YARRA CITY COUNCIL

Internal Development Approvals Committee

1.1 PLN18/0613 - 49-53 Bedford Street, Collingwood - Use (dwellings) and development of the land for a multi-storey building and removal of party wall easements

Figure 9: western streetscape of Bedford Street (including 4-10 Stanley Street)

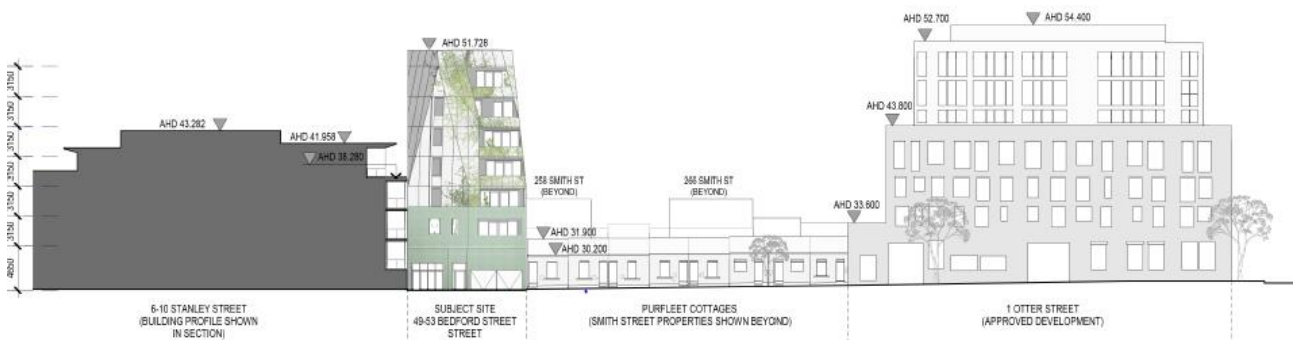
90. Figure 9 demonstrates how the development at the northern end of Bedford Street (1-5 Otter Street), whilst also extending to 7-storeys, has adopted reductions in height to the Purfleet Cottage interface, allowing for a more sensitive transition in scale along the streetscape. Of note, the direct abuttal to the northern-most cottage is only 1.7m higher than the cottage's roof. In comparison, this proposal would provide a wall 6.38m higher than the abutting single-storey cottage before any setbacks occur.

Figure 12: proposed widening of pedestrian link

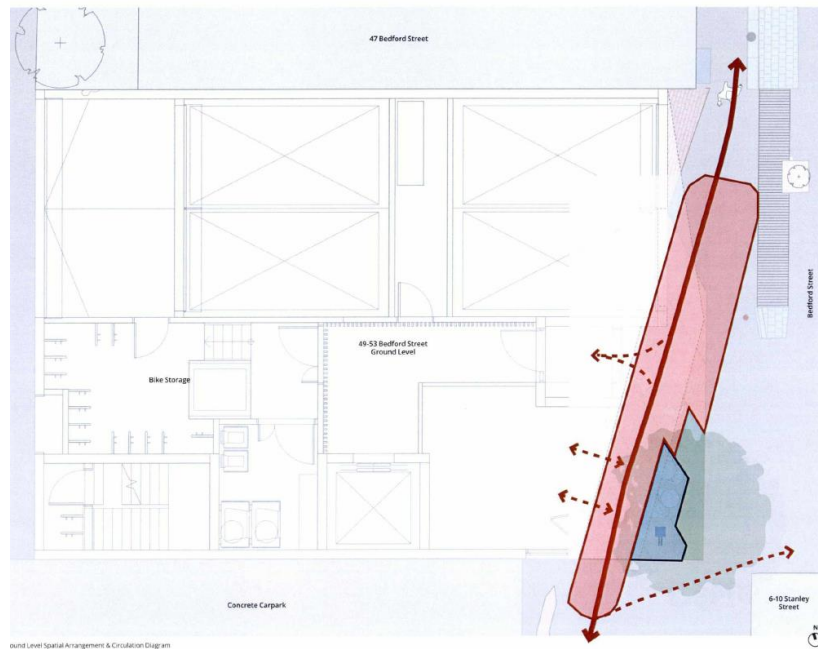
Improved outlook and a more direct pedestrian flow will be provided, thereby allowing for a safer connection through this thoroughfare. This connection is demonstrated in Figure 12.

Figure 14: Width of required pedestrian link

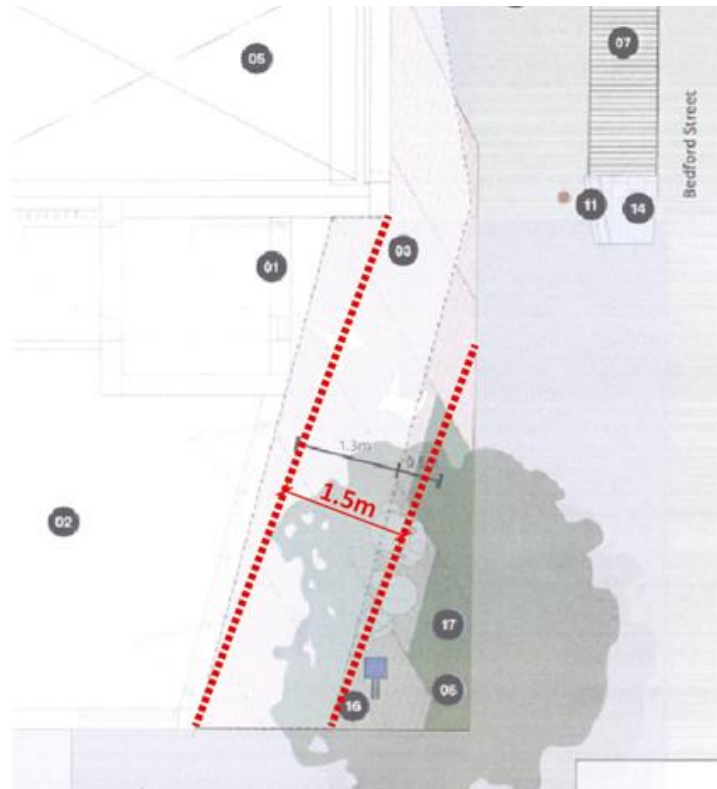
108. This advice notes that there is currently a 1.3m wide passageway between the subject site and 4-10 Stanley Street that is used for pedestrian access. An increase to a width of 1.5m is recommended, as outlined in Figure 14, to ensure that a clear path of travel is provided.

109. Figure 14 indicates that the 1.5m pathway is possible, with the dimensions of the bicycle repair station limited. Specifications provided for the repair station indicate that this infrastructure has a maximum width of 0.5m, including the signage at the top of the structure.

112. These recommendations are generally supported by Planning Officers (with the DDA requirements to be assessed at the building permit stage) however a degree of vegetation within this space is preferred if possible, to allow for a softening of the landscape and a substitute for the existing street tree, whilst maintaining pedestrian access. A condition can be added to any permit issued to incorporate these changes, with an additional condition requiring the provision of a landscape plan that demonstrates a reduced degree of landscaping within this space that works in conjunction with improved pedestrian circulation.

Figure 2 *Bedford Street looking south. Purfleet Cottages are on the right abutting the development site. The building at the end fronts Stanley Street and presents 5 storeys to Bedford Street. The scale, plain design and face/recycled brickwork comprise a sympathetic response to its context.*

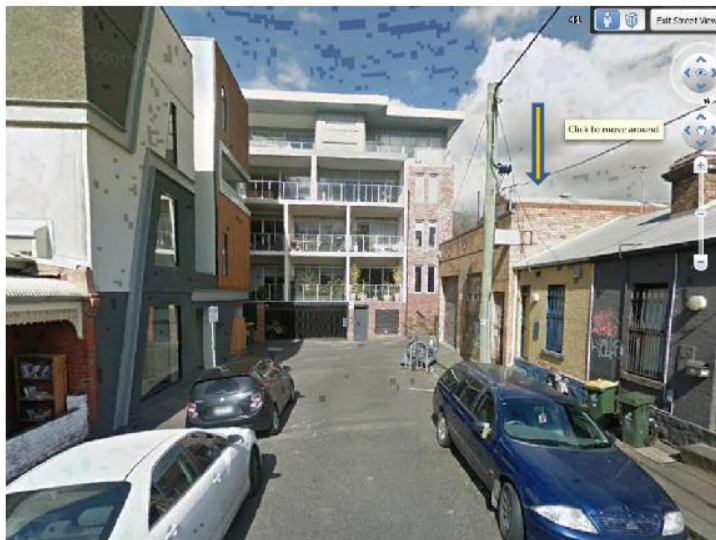
This part of Bedford Street, south of Otter Street, is a narrow, secluded *cul-de sac* located on the Collingwood Slope. Pedestrian access from the south is via a dog-leg lane off Stanley Street and from the north there is conventional pedestrian and vehicle access. "Purfleet Cottages" is undoubtedly the centrepiece. There is one single-storey Victorian dwelling opposite which is not covered by a Heritage Overlay but otherwise there are residential buildings of 4 – 5 storeys in various plain, semi-industrial and contemporary idioms and also employing face or recycled bricks and render. There is a robustness to the street character.

Concept Plan – Ground Level

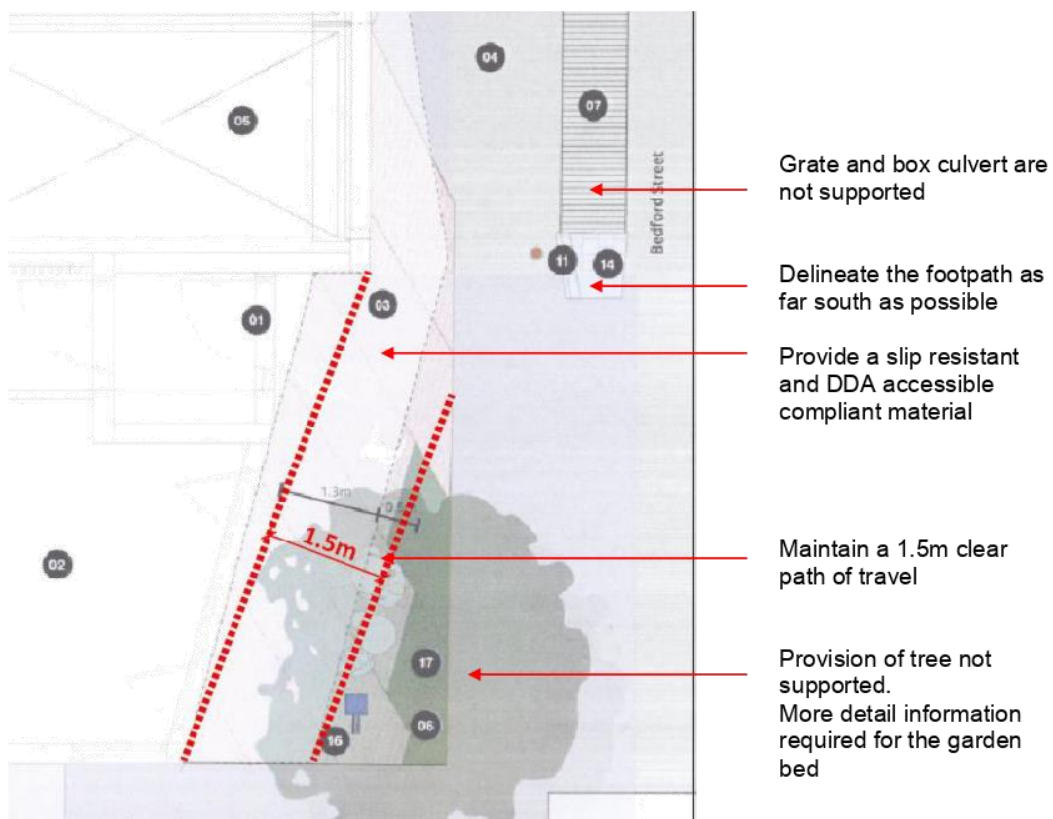
It is uncertain if the proposed nominated primary access will always be freely accessible (outdoor seating etc.) and as such the provision of the garden bed does not appear to be sustainable as this corner is susceptible to damage. Similarly, there needs to be more consideration given to clearance zone (1.8m X 0.6m) for the bike repair station to ensure that the clear path of travel is maintained.

Delineate the Bedford Street footpath (with 300mm wide bluestone dressed kerb) as far south as possible to ensure a clear path of travel is maintained along Bedford Street for pedestrian movement.

The proposed development presents drainage concerns and it is understood that engineering have raised concerns and requested for further information. From an urban design perspective, it is recommended to delineate the western footpath as far south as possible so there is clear path of travel maintained for pedestrian movement. Grates and box culvert for the cross over are not supported.

Image 6: Section C of dwg 1709/TP/18A

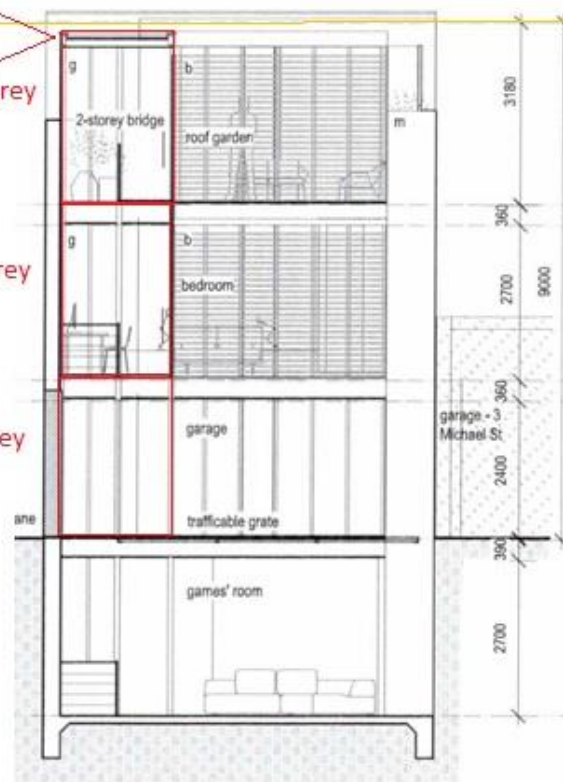
- (c) The proposed extension will have stairs and walkways connecting the existing dwelling to the roof terrace (above the two storey extension). As shown in the below section (taken from Section 2 of 2, dwg 1709/TP/18A of the Decision Plans), the upper level walkway must remain open to the sky otherwise it will constitute a third storey (which is prohibited). It is important to note that it is the walkway which creates the third storey, not the stairs. A condition of any permit issued should require the walkway to be unroofed.
